STAR ONLINE PUBLICATION

Case Number: S2523000015

Symptom/Vehicle Issue: Replacement Exterior Mirror Glass Connector Does Not Match For Blind Spot.

Fig 1.

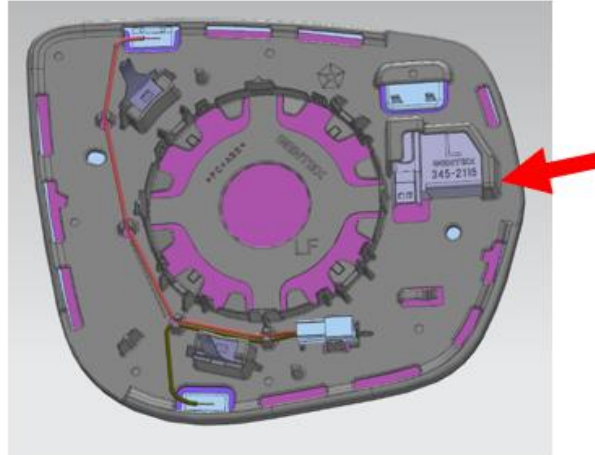
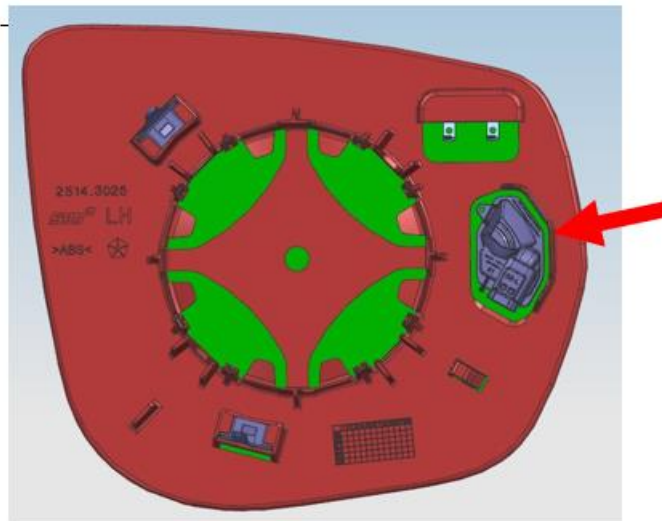
Discussion: During 2024 production there was an engineering change on exterior mirrors. The glass blind spot indicator changed. The “early mirror glass” design with the early blind spot is no longer available in MOPAR, however there is a “new mirror glass” design with the new blind spot monitor indicator for all the model years for production and service. This “new mirror glass” has a different connector for the blind spot indicator. An adapting jumper harness has been created to allow installation of the new mirror glass to the early mirror wiring with the new blind spot glass.

Repair: Remove the exterior mirror glass from the door mirror assembly. Compare the connections to the images below. Fig 1 shows an early design mirror that will require the adapter jumper harness. Fig 2 shows the new mirror glass design that does not require an adapter jumper harness.

Requires Adapter Jumper Harness When Installing New Design Mirror Glass.

New Mirror Glass Design
Adapter Jumper Not Needed.

- If you have an old mirror and need replacement glass (Fig 1) – order a service glass + a JUMPER to allow a connection to the old mirror wiring. Jumper 68673054AA
- If you have a new mirror that needs replacement glass (Fig 2) – order a service glass only - no jumper needed.
